**SUBJECT:** NuScale Power, LLC Submittal of Approved Version of "Subchannel Analysis Methodology," TR-0915-17564, Revision 2

“Subchannel Analysis Methodology”, TR-0915-17564-P-A, Revision 2, proprietary version

SUBJECT: FINAL SAFETY EVALUATION FOR NUSCALE POWER, LLC TOPICAL REPORT-  
0915-17564, REVISION 2, "SUBCHANNEL ANALYSIS METHODOLOGY"

**Figure 2. Comparison of nucleate boiling heat transfer correlations**

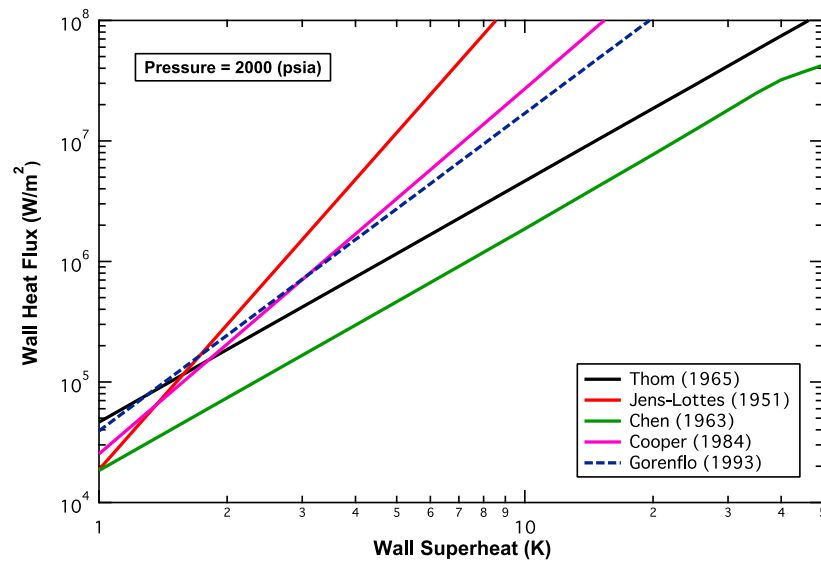
In modern boiling heat transfer models, the forced convection and nucleate boiling components are added in a similar fashion to that used in the THSP correlation option. The NRC staff concludes that the THSP correlation option provides a conservative result because of three factors:

component would be underpredicted by about a factor of about 2 for a void fraction of 50 percent.

3. When compared to modern nucleate boiling correlations for high-pressure conditions, the THSP correlation is quite conservative, as shown in Figure 2. For example, at 13.79 MPa (2,000 psia) and a wall superheat of 10 degrees C (18 °F), the THSP correlation gives a wall heat flux about one-quarter that of the Gorenflo model that is used in the TRACE code.

Figure 6-12. Bennett Flow Regime Map with Example Off-Normal Conditions at MCFHR

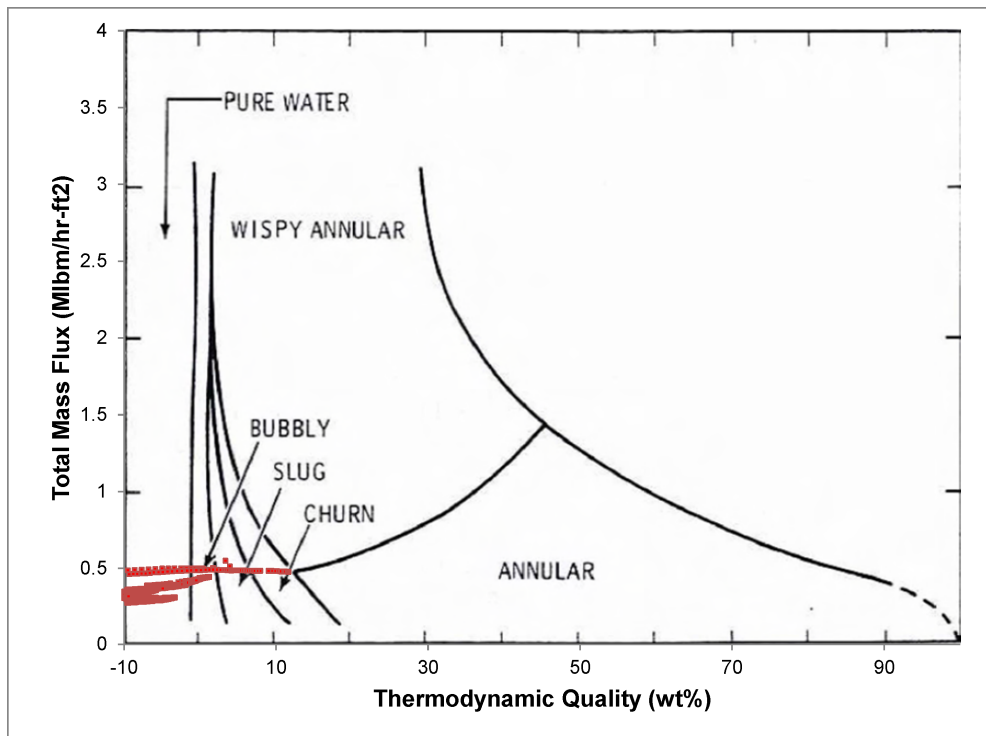
**Section 2.2 of Reference 8.2.6 describes several two-phase flow conditions, local pressure phenomena, and a free-field not dominated by wall friction that are not applicable to NuScale applications. Section 6.3 and Figure 6-12 demonstrate that the NuScale design is similar to conventional PWRs, for which VIPRE-01 was designed, with respect to equilibrium qualities and flow regime.**
